Access Compliance Report

Public Rights-of-Way

(Pedestrian Signals)

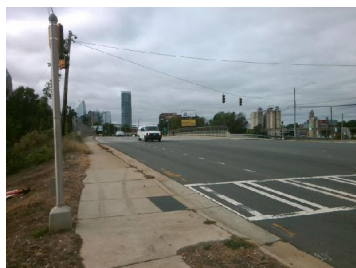
Surveyor Notes: TX HT 1/4

PROW/ADA: R410.6, TMUTCD 4e.08, R404.2, R404.3, R406.2

Possible Solutions: Replace Signal Push Button With APS Button on New Post. Remove & Replace Sign.
